Request for Additional Information No. 12, Revision 0

U. S. EPR Standard Design Certification

AREVA NP Inc.

SRP Section: 06.02.06 - Containment Leakage Testing

Table 3.5-2—Containment Isolation Equipment I&C and Electrical Design (5 Sheets)

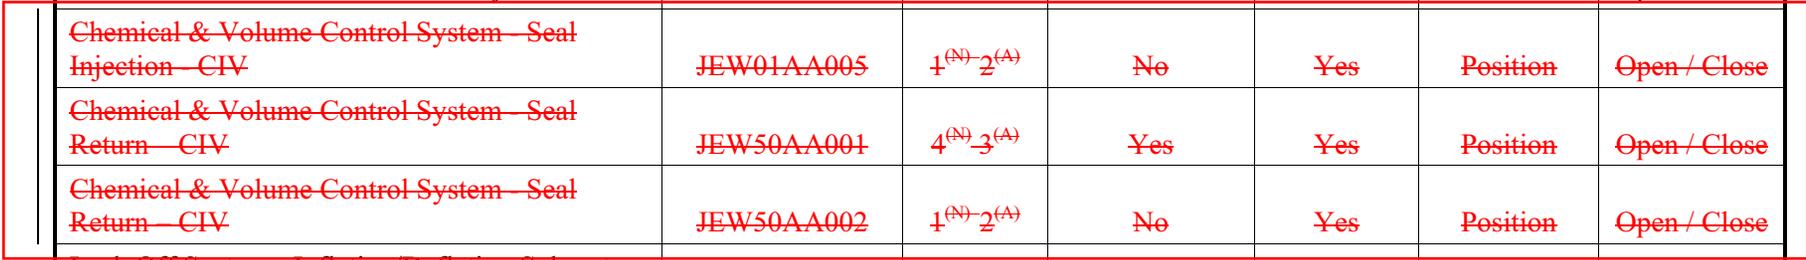
4. The valve (KTC10AA010) should be listed in FSAR, Tier 1, Section, 3.5. This valve will be added to Table 3.5-2 as shown in the enclosed FSAR markup.

Figure 2.3.3-1—Severe Accident Heat Removal System Functional Arrangement

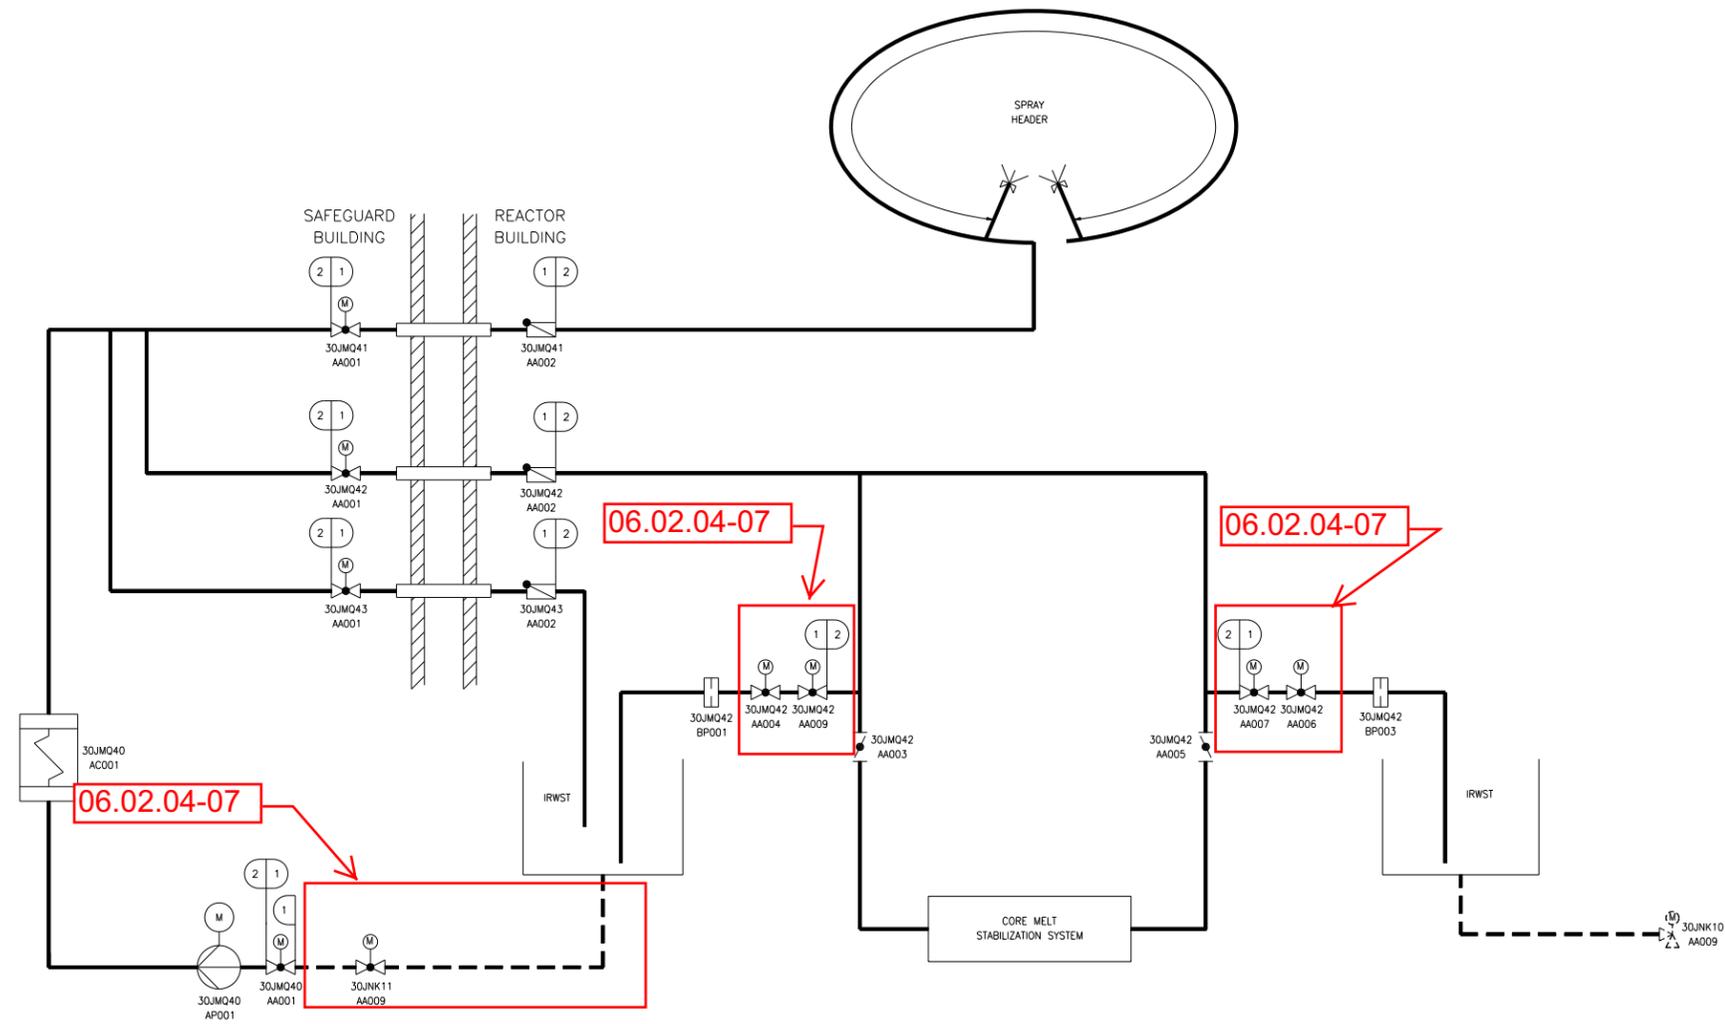
7. The class of piping represented on FSAR, Tier 1, Figure 2.3.3-1 shows the piping from the IRWST is Class 1 not the T-connection. The piping from the IRWST through devices JMQ42BP001 and JMQ42BP003 is classified a Class 1 to preclude the possibility of obstruction of the IRWST water to the Safety Injection function or potentially draining IRWST water to the spreading area. FSAR, Tier 1, Figure 2.3.3-1 will be modified to add two isolation valves and to place the class break on the lines at the second isolation valve from the IRWST as shown in the enclosed FSAR markup.

8. FSAR, Tier 1, Figure 2.3.3-1 is not correct. FSAR, Tier 1, Figure 2.2.2-1 is correct. Figure 2.3.3-1 will be modified to indicate the representation for the 30JNK11AA009 as a motor operated valve as shown in the enclosed FSAR markup.

Figure 3.5-1—Representative Containment Isolation Valve Arrangement

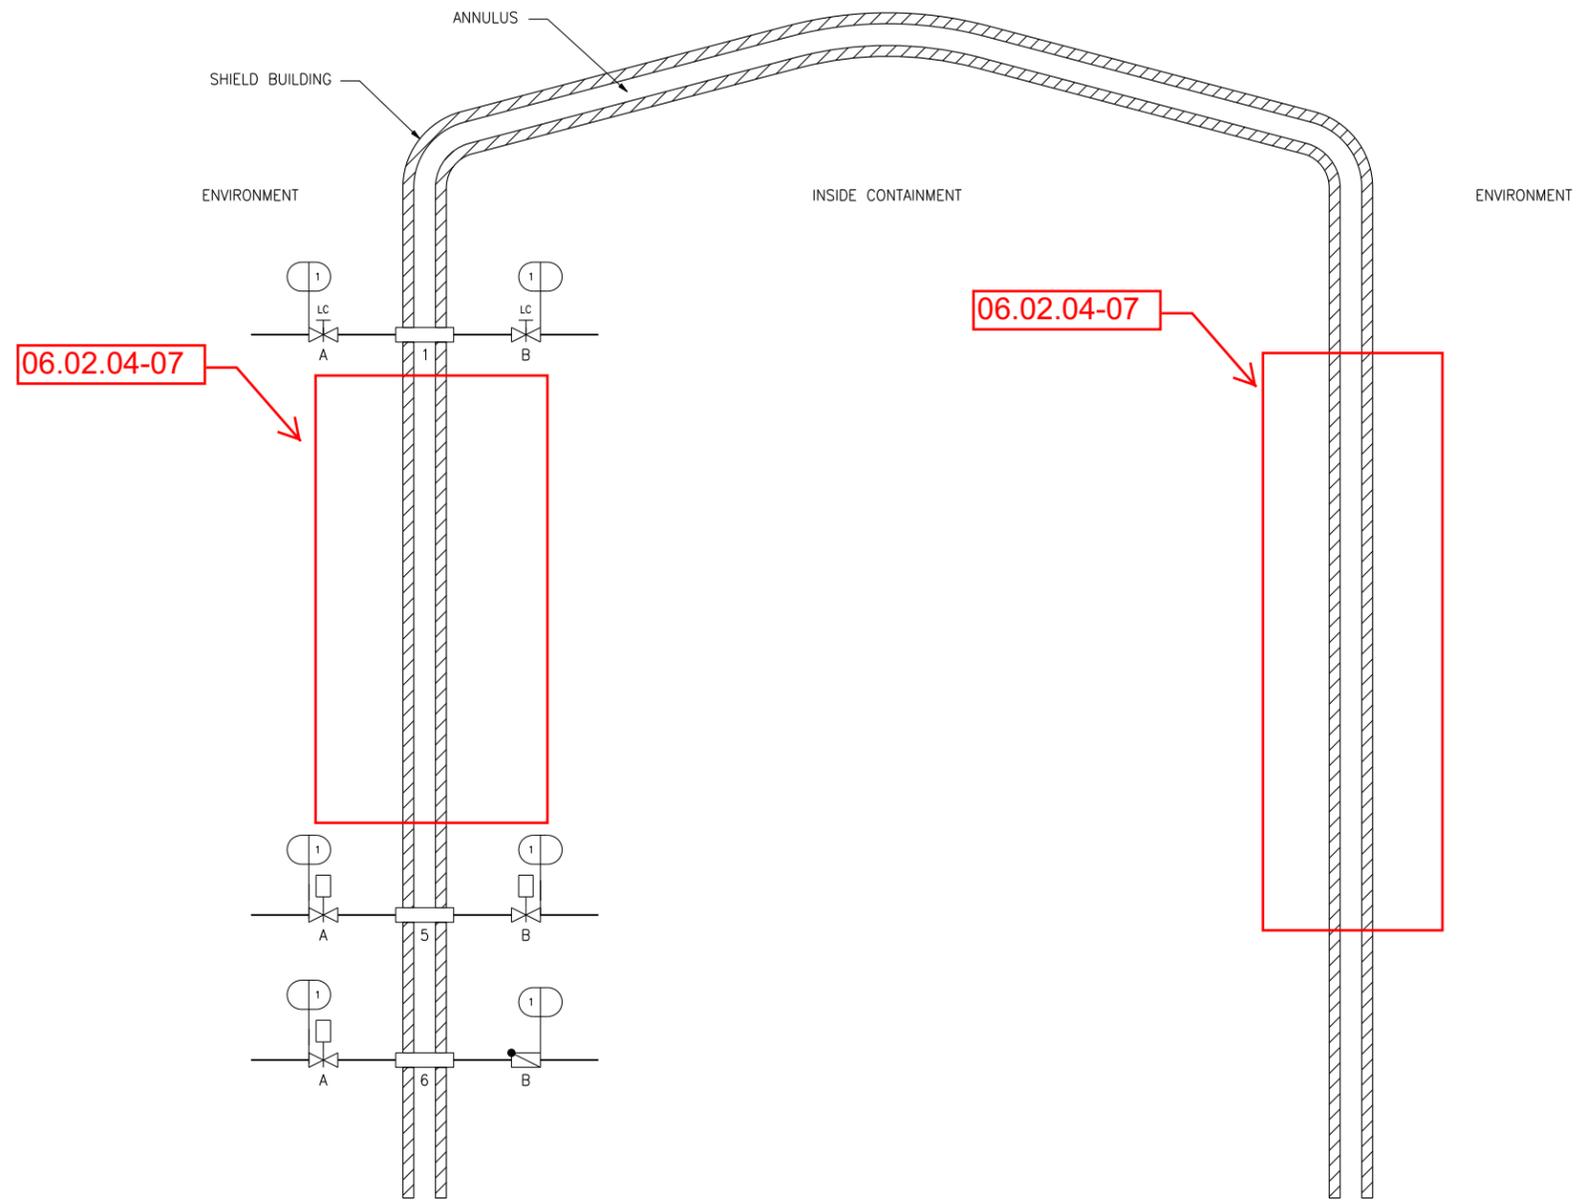
5. Configuration type 2, 3, 4, 7 and 8 arrangements are not required for FSAR, Tier 1, Section 3.5 and will be deleted from Figure 3.5-1 as shown in the enclosed FSAR markup.

Figure 1.3-1—Functional Arrangement Symbol Legend

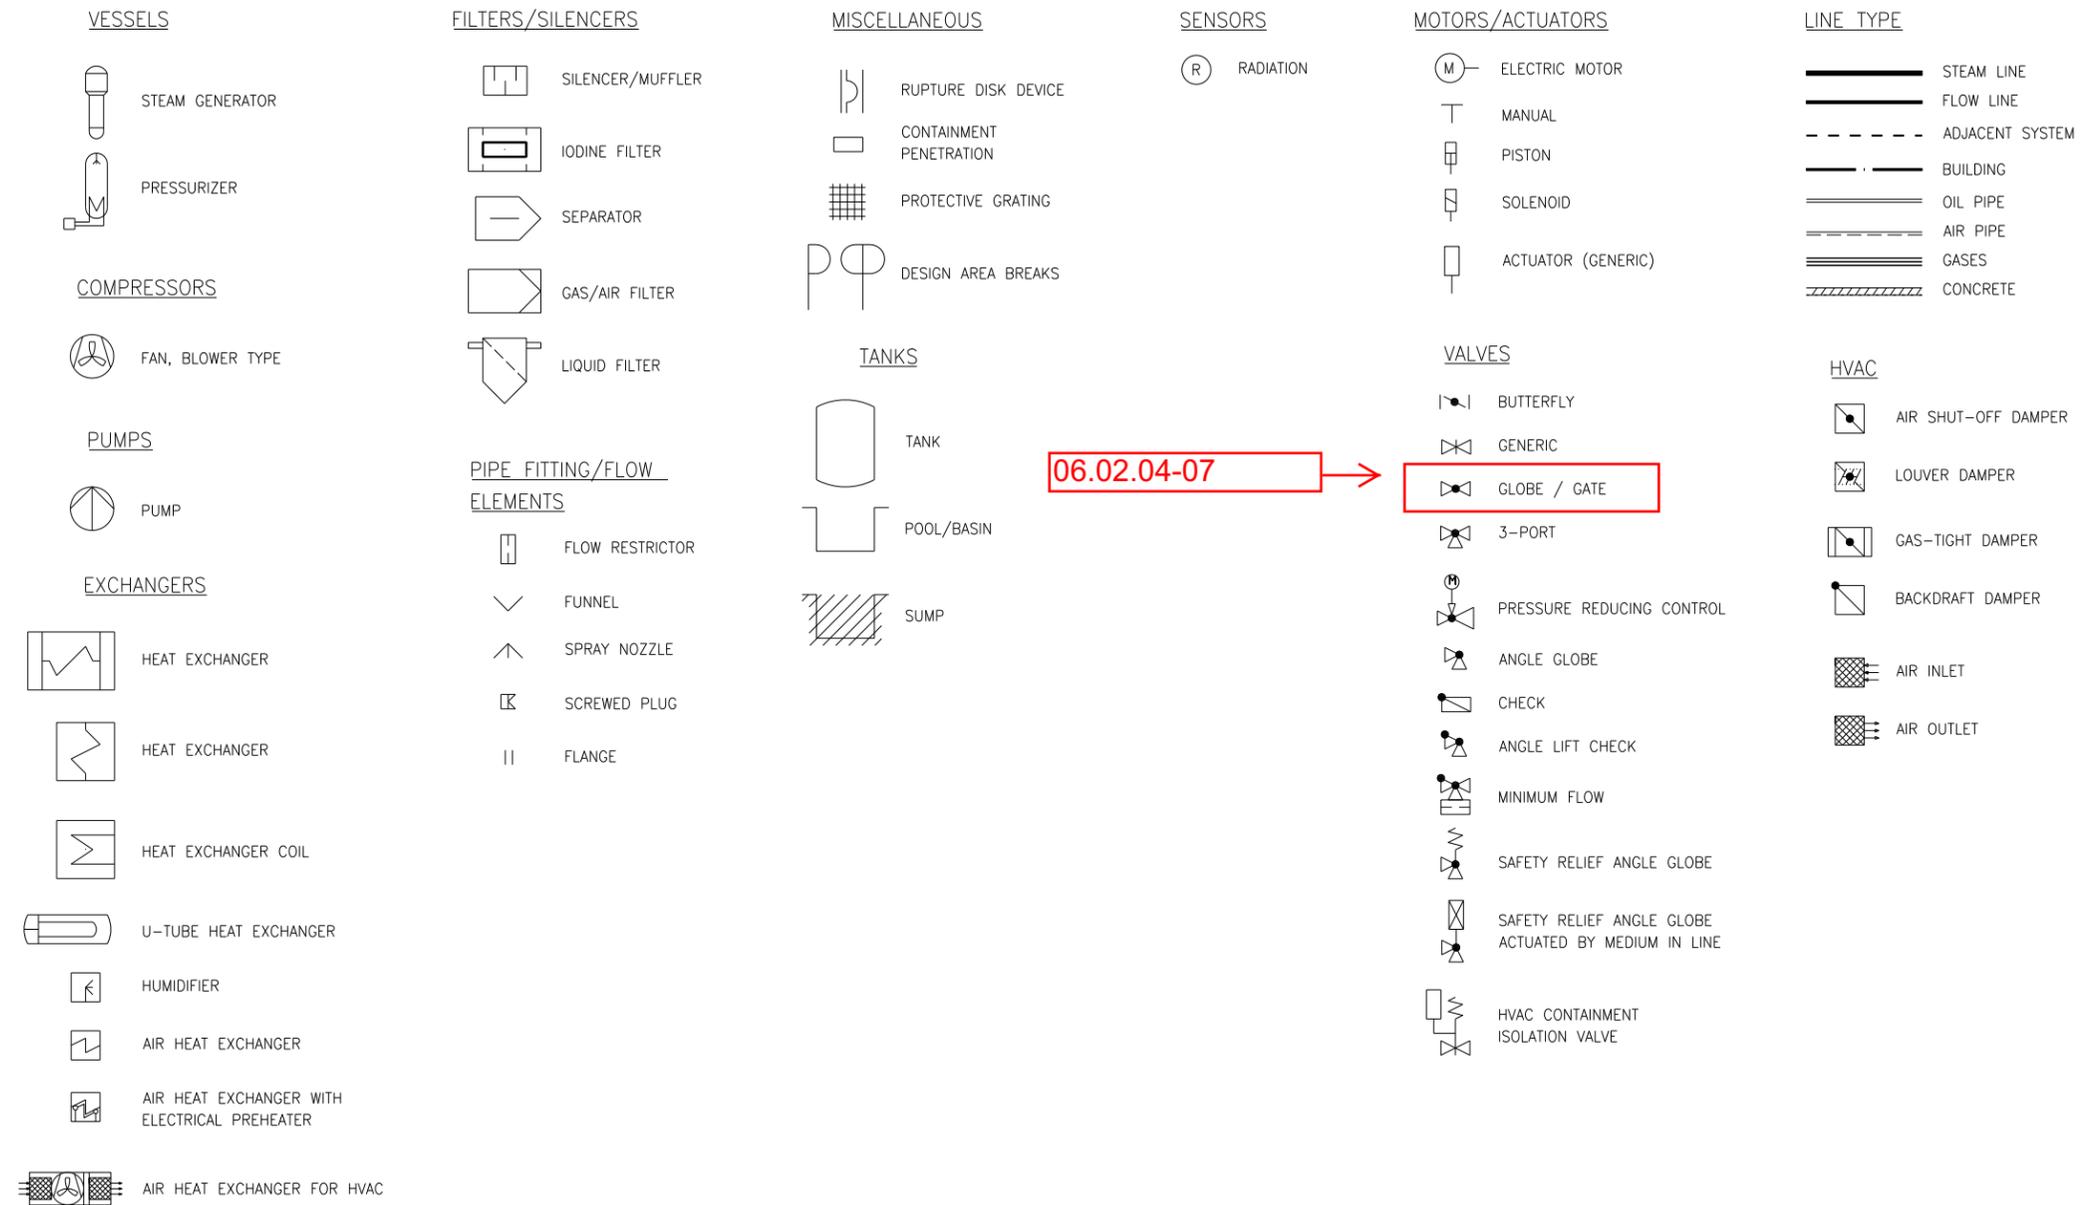
6. The symbol for the valves in FSAR, Tier 1, Figure 1.3-1 will be modified to indicate that the symbol represents a globe or a gate valve as shown in the enclosed FSAR markup.
